Comments from DC Ranch and Ironwood Village Mack Innovation Park – North Parcel – Phase II

The DC Ranch Community Council and Ironwood Village Homeowners Association, representing the 8000 and 1800 Scottsdale residents respectively, have reviewed the initial submittal for the Mack Innovation Park, North Parcel – Phase II. The land abuts DC Ranch’s southwestern border and is near Ironwood Village and other residential neighborhoods. As this application interacts with the South Parcel – Phase I application, some repetition is necessary to adequately address the development.

Drawing referred to in: Visual Impact and Arciferal Design, (2)

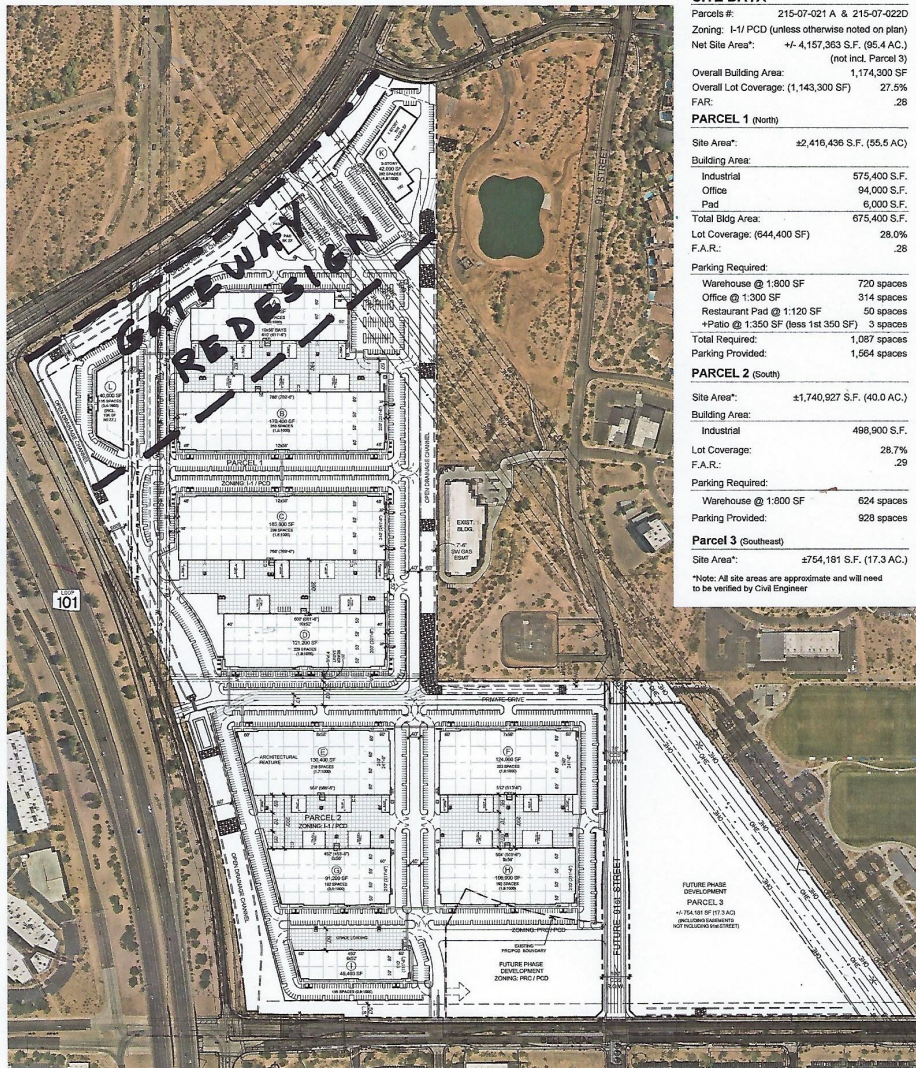
2. The eastern Pima/Princess intersection serves as the “gateway to north Scottsdale.” Development along this stretch of road (heading north on Pima) should honor and enhance the “gateway.” See drawing on page 3. This would include much smaller buildings with diverse but complementary architecture that will attract tenants for a variety of uses that are compatible to adjacent neighborhoods. The area under the power lines should be artistically landscaped, not used as a parking lot. Entrance design elements and public art should be added.

Gateway to North Scottsdale – the gateway should include much smaller buildings with diverse but complementary architecture that will attract tenants for a variety of uses that are compatible to adjacent neighborhoods. Entrance design elements and public art should be added. The area under the power lines should be artistically landscaped, not used as a parking lot. Parking should be minimally visible from Pima Road
